# Detailed Noise and Vibration Impact Statement (Parramatta)

<b>Project Name:</b>	Sydney Metro West		
<b>Client Name:</b>	Sydney Metro		
<b>Project Address:</b>	Delta will demolish buildings across the following sites: <ol style="list-style-type: none"> <li>1. Parramatta</li> <li>2. Clyde</li> <li>3. Westmead</li> </ol>		
<b>Project Description/Scope:</b>	Delta Pty Ltd (Delta) is responsible for the full structural demolition of existing structures including removal of all hazardous materials of the Sydney Metro West Demolition Project.		
<b>Prepared By:</b> (Consulting Engineer)	Name: ██████████	Signature: ██████████	Date:25/10/2021
<b>Reviewed By:</b> (Project Manager)	Name: ██████████	Signature: ██████████	Date:25/10/2021
<b>Authorised By</b> (Project Director):	Name: ██████████	Signature: ██████████	Date:25/10/2021

**Figure 1: Sydney Metro West Alignment**

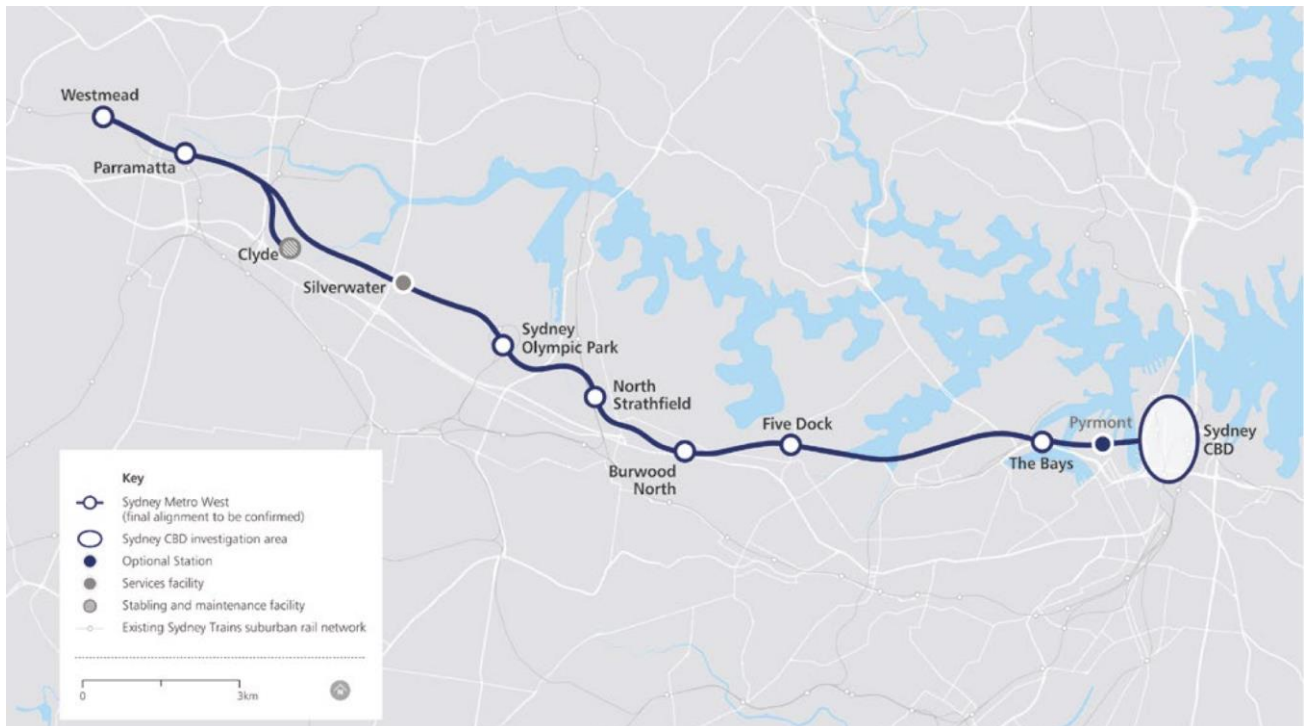
21.01	27/09/2021	DLT	DKADYAN	SMWSDDS-DLT-PTA-PA-PLN-000042	References		Amended	Minor Non-Compliance	Y
								SMWSDDS-DLT-PTA-PA-PLN-000042	References			Minor Non-Compliance	Y
				22	7/09/2021	SMD	JIEROKLIS	SMWSDDS-DLT-PTA-PA-PLN-000042	Figure 1	N/A	Figure 1 is out of date. There is no longer a proposed Metro station at Rydalmere. Please use the attached figure instead.	Observation	Y
								SMWSDDS-DLT-PTA-PA-PLN-000042	Figure 1	N/A		Observation	Y

22.01	27/09/2021	DLT	DKADYAN	SMWSDDS-DLT-PTA-PA-PLN-000042	Figure 1	N/A	Updated	Observation	Y
								SMWSDDS-DLT-PTA-PA-PLN-000042	Figure 1	N/A		Observation	Y
				23	13/09/2021	HBI	JROBERTSON	SMWSDDS-DLT-PTA-PA-PLN-000042	2.1	SSI	Correct reference for SSI should be Sydney Metro West - Concept and Stage 1 Conditions of Approval (SSi 10038), not "Demolition phase"	Observation	Y
								SMWSDDS-DLT-PTA-PA-PLN-000042	2.1	SSI		Observation	Y

Figure 2: Parramatta Site Map

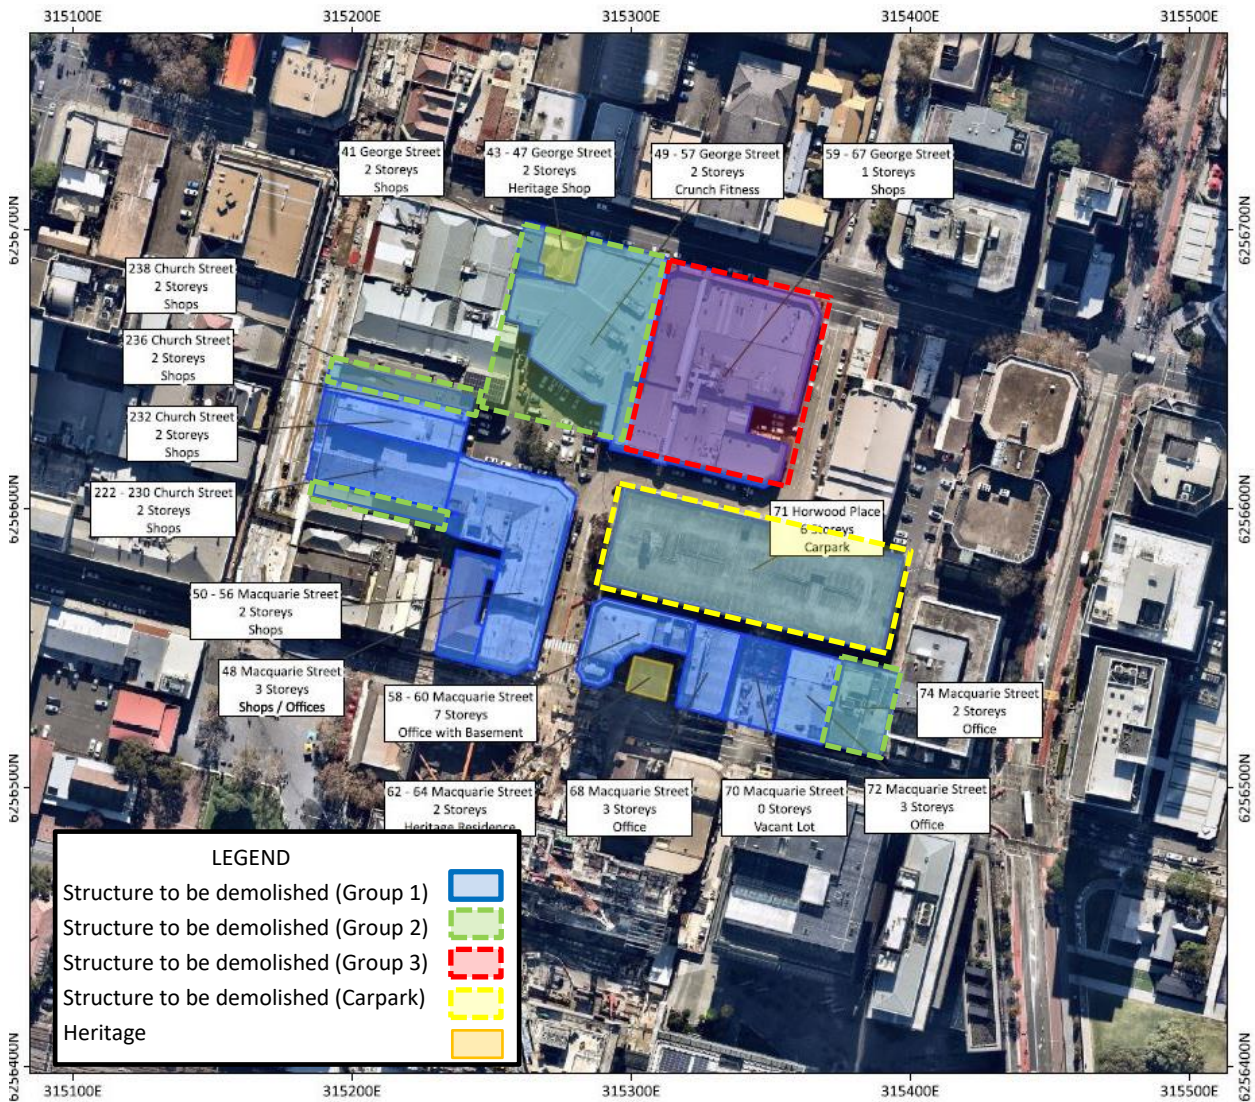
25.01	27/09/2021	DLT	DKADYAN	SMWSDDS-DLT-PTA-PA-PLN-000042	2.2	N/A	Updated wording in management plan "Sydney Metro will advise Delta of the items to be salvaged and the location where the items are to be delivered. Delta will then carry out this work prior to commencement of heavy structural demolition. Storage of items will be offsite at location as advised by Sydney Metro. This will remove any risk of damage as a result of site works"	Observation	Y
								SMWSDDS-DLT-PTA-PA-PLN-000042	2.2	N/A		Observation	Y
				26	13/09/2021	HBI	BMCLENNAN	SMWSDDS-DLT-PTA-PA-PLN-000042	Figure 2	N/A	No legend in Figure 2 to determine which is demolished or demolished	Observation	Y
								SMWSDDS-DLT-PTA-PA-PLN-000042	Figure 2	N/A		Observation	Y

26.01	27/09/2021	DLT	DKADYAN	SMWSDDS-DLT-PTA-PA-PLN-000042	Figure 2	N/A	Amended	Observation	Y
								SMWSDDS-DLT-PTA-PA-PLN-000042	Figure 2	N/A		Observation	Y
				27	13/09/2021	HBI	BMCLENNAN	SMWSDDS-DLT-PTA-PA-PLN-000042	Figure 2	NVM15	Is site office / Amenities proposed after demolition of Crunch Fitness? How will the proposed location aid in mitigation NVM15?	Observation	Y
								SMWSDDS-DLT-PTA-PA-PLN-000042	Figure 2	NVM15		Observation	Y

27.01	27/09/2021	DLT	DKADYAN	SMWSDDS-DLT-PTA-PA-PLN-000042	Figure 2	NVM15	NVM15 no longer exists. Note after Figure 3 regarding Crunch Fitness	Observation	Y
								SMWSDDS-DLT-PTA-PA-PLN-000042	Figure 2	NVM15		Observation	Y
				28	13/09/2021	HBI	BMCLENNAN	SMWSDDS-DLT-1NLE-PLN-000042	General	N/A	Check cross references and duplication of references throughout document.	Observation	Y
								SMWSDDS-DLT-1NLE-PLN-000042	General	N/A		Observation	Y
